ULDR 47-21 Revisions Stakeholder Meeting

March 18, 2022

Clarifications of Some Issues Raised

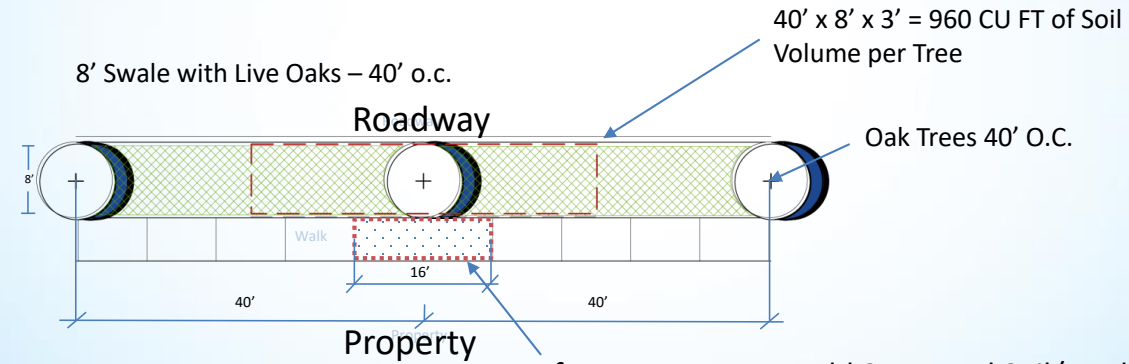
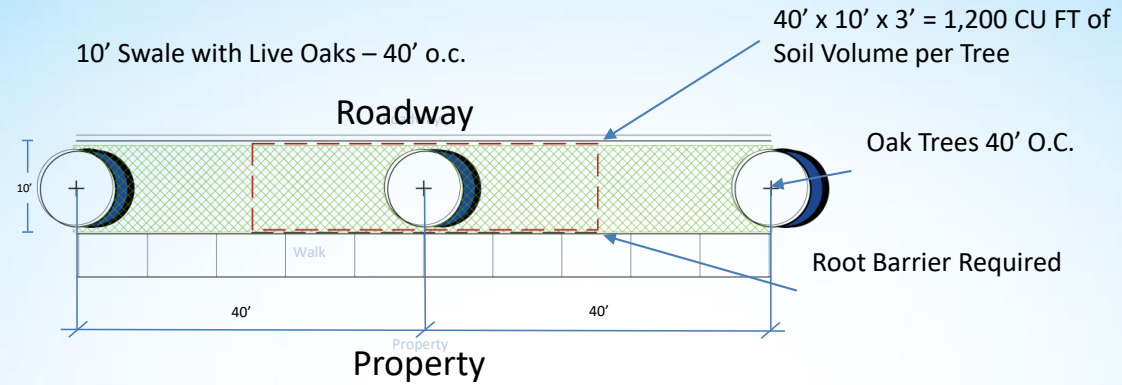
- **Concern:** Proposed ordinance increases the number of trees required in some cases

Response: The number of required trees has not increased in any of the zoning districts or categories. They all stay the same, except that the required number of street trees has actually been reduced because the drive ways can be subtracted.

Modular Suspended Pavement Cost

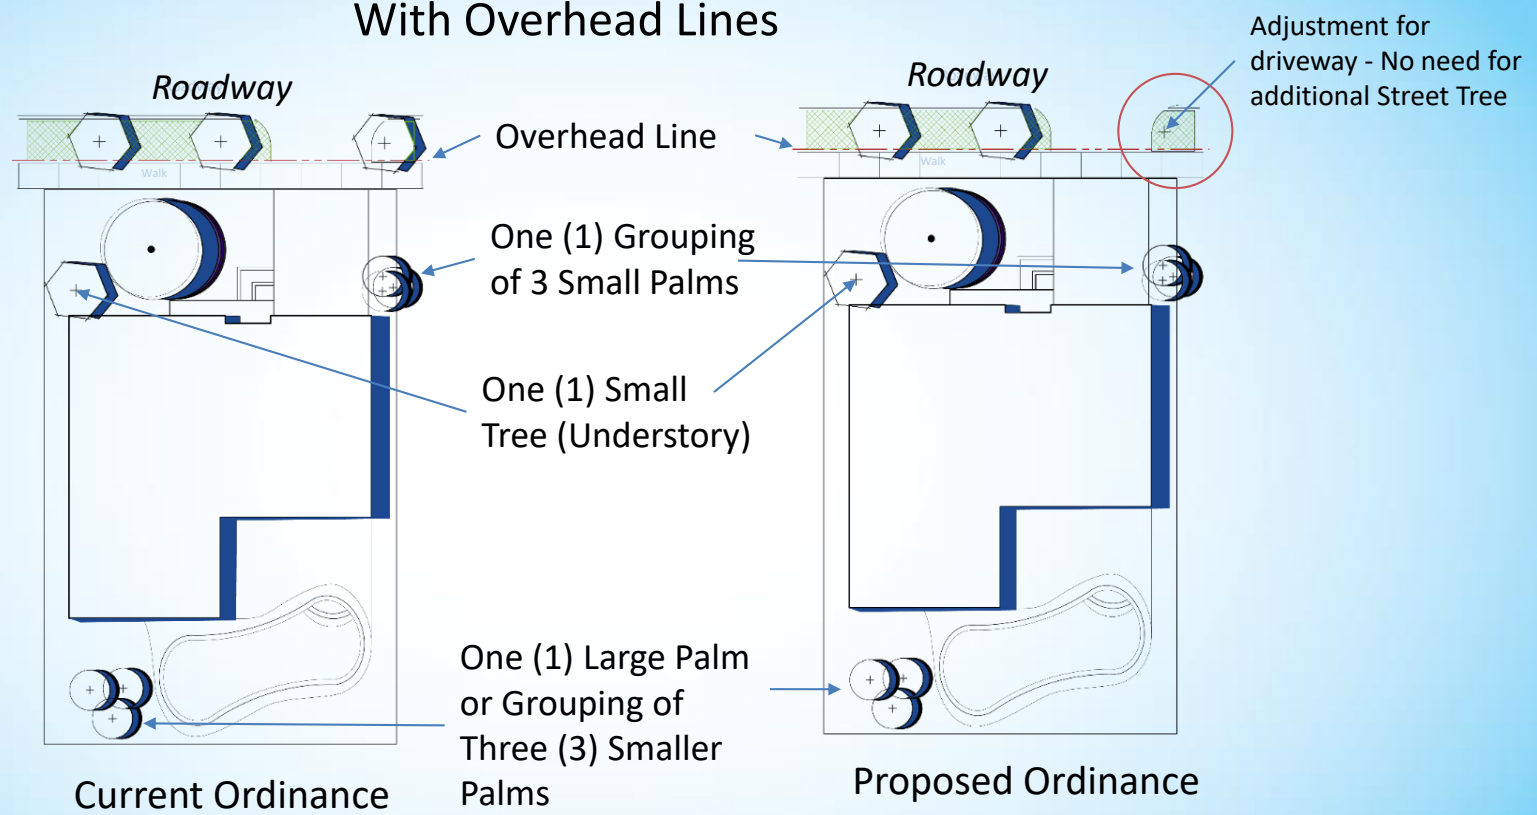
- **Concern:** Proposed ordinance requires the installation of structural soils and modular suspended pavement systems, which will dramatically increase costs for builders/developers

Example: 9' x 18' island with a large tree

Net cost: \$5,659.33 or

\$7,916.99
